CALIFORNIA ENERGY COMMISSION

LOS ESTEROS CRITICAL ENERGY FACILITY 2 (03-AFC-2) DATA REQUESTS

**Los Esteros Critical Energy Facility II
(03-AFC-2)
Data Requests**

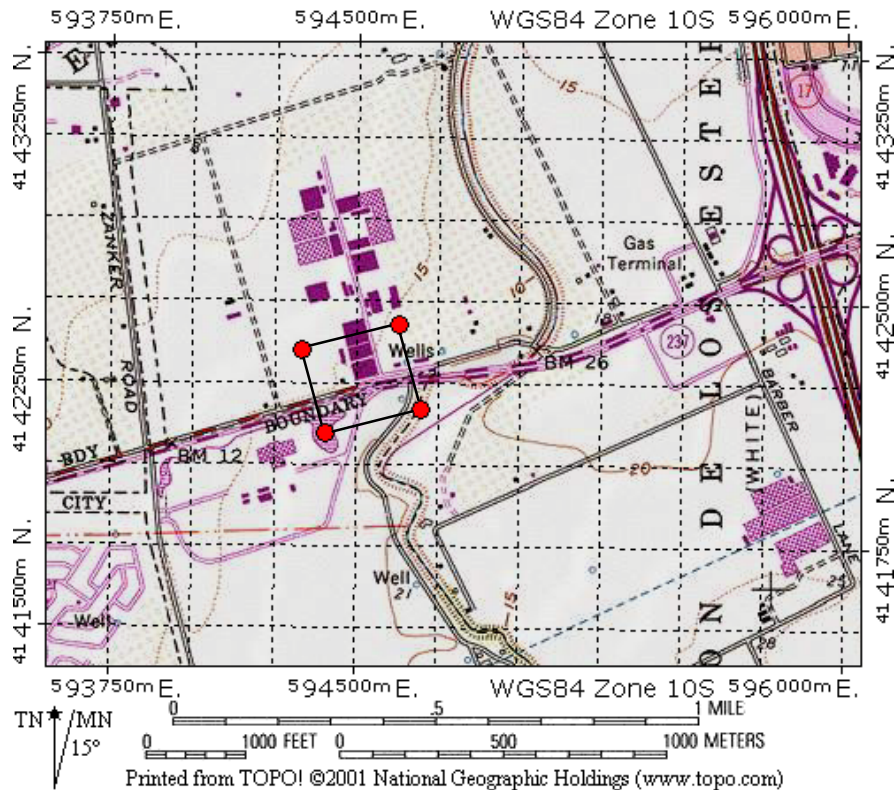
10. Staff checked the listed "Fenceline Receptors" starting on line 379 of the modeling file "LE00_01B.dat". The four corners of the coordinate set are marked on the map below:

The UTM coordinates used for the facility boundary appear to be displaced slightly to the south of the actual facility location. Preliminary investigation indicates that all coordinates used in the modeling (i.e. for both Phase 1 and Phase 2) were displaced in this manner. Please check the modeling receptor locations for accuracy and provide a discussion of this apparent error and if remodeling is necessary.
